Lead Local Flood Authority

RE: DC/26/0592 Land at Lower Broadbridge Farm Billingshurst Road Broadbridge Heath Horsham West Sussex RH12 3LR

Further to our recent comments dated 01/09/2026 we have been made aware of additional relevant documents available on the planning portal. Please see below original comments, updated comments in [blue](#) and latest comment in [green](#)

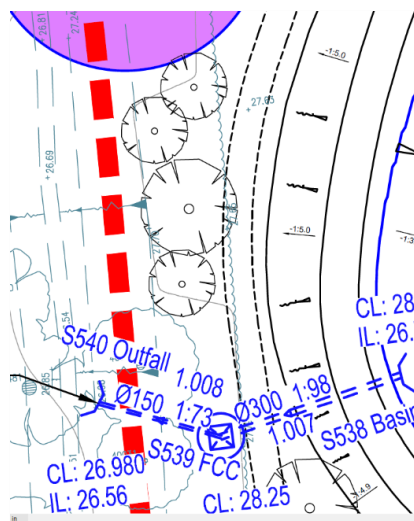
The ditch bed level is, at best, similar to, and in some locations higher than, the outfall levels immediately downstream of the discharge points (including S540). For effective drainage, the outfalls should be set above the receiving ditch bed level to ensure positive discharge. Where practicable, efforts should therefore be made to raise the outlet levels.

We note that the downstream culvert invert level (a fixed control level) is 25.84m, indicating that suitable outlet levels may be achievable. However, this is likely to require regrading of the receiving watercourse. Please therefore consider this matter and submit a plan detailing the proposed regrading and maintenance of the watercourses receiving discharge from the development, extending downstream to the culvert beneath the private track to the north-west of the site.

This updated comment remains outstanding, current watercourse levels as stated will not facilitate the free drainage of surface water, with outfall invert levels lower than downstream bed levels (see below example – outlet IL 26.56m AOD compared to downstream bed level 26.81m AOD – meaning outfall pipe will be submerged):

Either the outlet levels will need to be raised (recommended minimum 150mm above highest downstream ditch bed level) or the watercourse will need to be reprofiled.

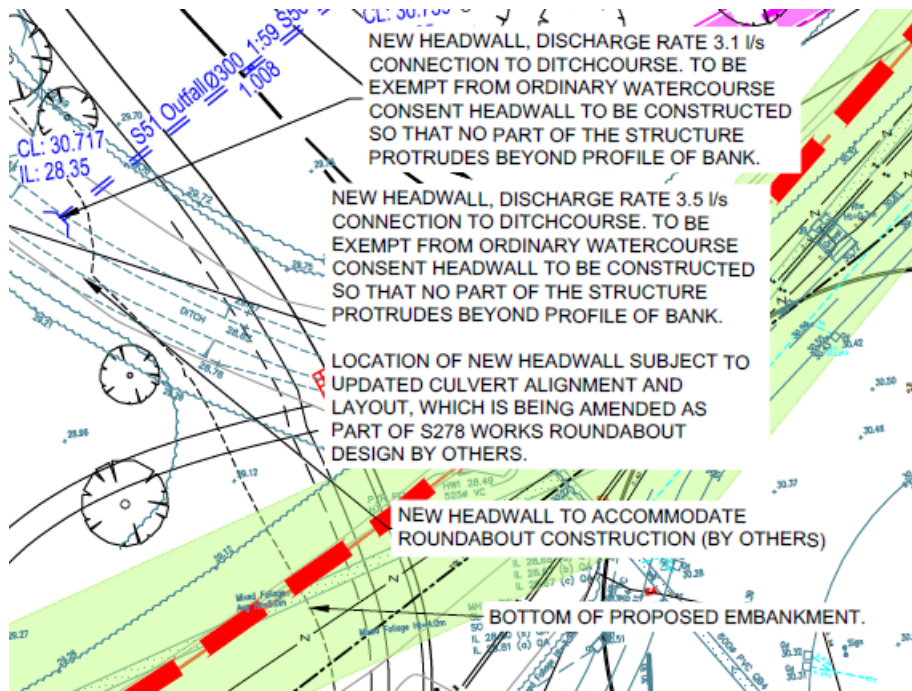
- This has been completed for outfall headwalls, however please also update for any culverts and watercourse realignment, for example in the area highlighted below (which appears to require a culvert for the access road and realignment via S278 works):

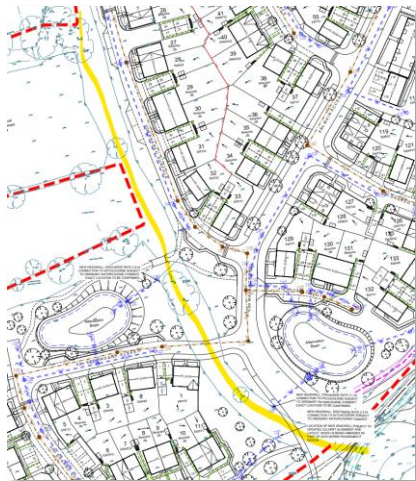
e. An exceedance route plan (this can be a separate document if required)
It is noted we have a levels strategy, however an exceedance route plan is still outstanding.
This has been provided and is satisfactory.

(from drainage layout with watercourse marked in yellow)

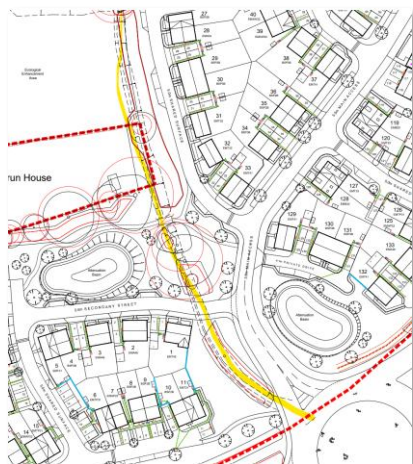
f. We also note there will be amendments to the existing watercourse, please ensure the plan includes the updated course as proposed:

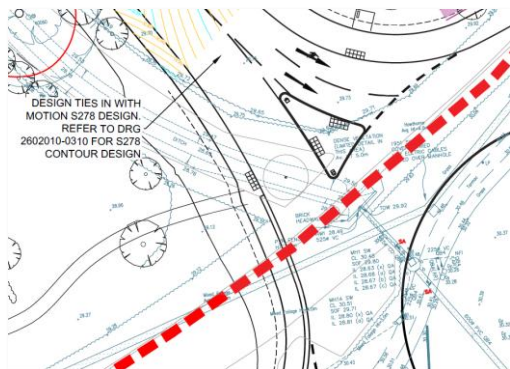
There are still conflicts with the revised road layout and the existing watercourse layout, see below example. We note the Applicant states at 3.5.3 *“There is an existing SW culvert which discharges into the existing watercourse on site, at the location of the new roundabout arm into the site. This is proposed to be extended into the site as part of the separate highway works, to accommodate the new roundabout design. It is not envisaged that these*

works will affect the proposed development”. However we would still require a plan showing the finalised drainage layout at this stage of planning.

The latest plan provided is acceptable, the Applicant should continue to engage with the OWC process where applicable.
